# UNITED STATES PATENT AND TRADEMARK OFFICE

10/502,416

**Office Action Summary**

### **DETAILED ACTION**

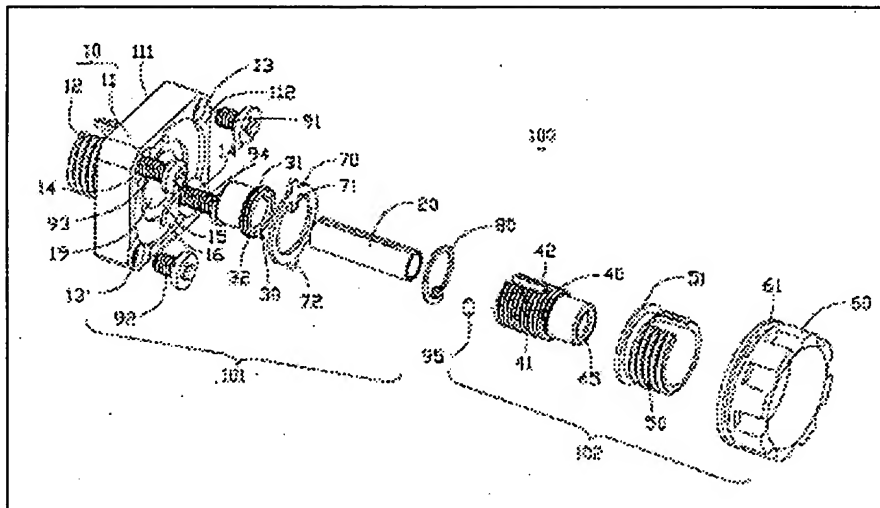
Claim 17 and 36 are rejected under 35 U.S.C. 102(e) as being anticipated by Wu et al. (US 6,666,586 B2, hereinafter “Wu”). Wu discloses in Fig. 5, A sleeve mount assembly (100) comprising a sleeve mount (111) having an interior for accommodating and securing a

cylindrical sleeve (40) having a longitudinal slit (41), the sleeve mount assembly further comprising optical plug-in connections (12, 50) for accommodating ferrules of two optical plug-in connectors introduced from opposite directions, the sleeve mount having means for securing the sleeve against rotation about a sleeve axis (70, 71, 72, 151) wherein the means for securing are arranged in a central part of the sleeve mount and are restricted to the central part of the

Claims 27 and 37, the two separate accommodating parts are the two connection members (12, 50) wherein the means for securing are arranged and retained between the accommodating parts.

Fig. 5

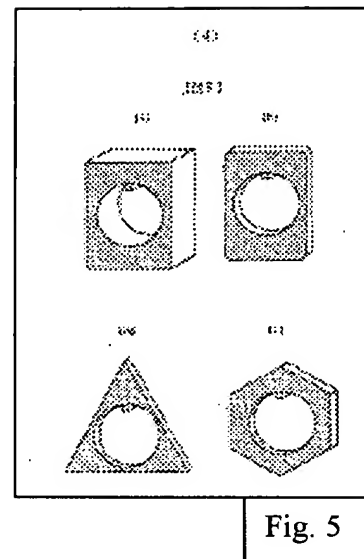
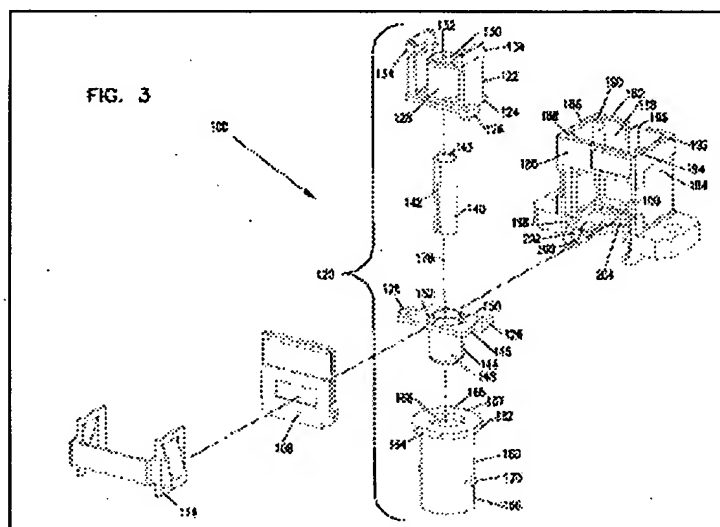
Ishikawa discloses a portion of a connector (Fig. 1) having a securing plate (3) retained in a rotationally secure manner and engaging in the slit of the slit sleeve (11) by way of a protuberance (Fig. 5). However, Wu does not explicitly disclose a second flange which abuts to the first flange (2).

It would have been obvious at the time the invention was made to a person having ordinary skill in the art to the securing plate (Fig. 5) may be used in Wu's adapter as a mean of securing the sleeve from rotation with the

motivation of maintaining alignment to "decrease the fluctuation in the loss by repetitive attaching and detaching" (PURPOSE of Ishikawa patent). Furthermore, Puetz's

As to claims 30 and 40, Ishikawa discloses the securing plate has a central opening, the sleeve is plugged through the central opening, and the protuberance is arranged on an inner periphery of the opening (see Fig. 5).

As to claims 32, 34, 35, and 41-44, Ishikawa discloses the adapter comprises means for defining the angle of rotation orientation provided on the securing plate and the accommodating parts wherein the peripheral contour allows radial play (see Fig. 5 with the triangular and hexagonal securing plate), and these embodiment of securing plates are bevels.

Fig. 1

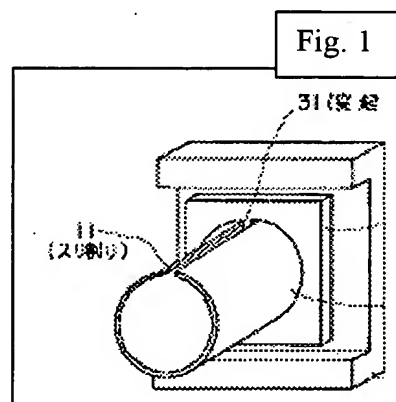
As to claims 29 and 39, Ishikawa discloses the flange parts contain depressions for accommodating the securing plate, and the depressions each have a peripheral contour adapted to a peripheral contour of the securing plate (see Fig. 1).

As to claims 31 and 41, Ishikawa discloses the protuberance of the securing plate engages the slit of the sleeve without projecting into an interior of the sleeve (see Fig. 1).
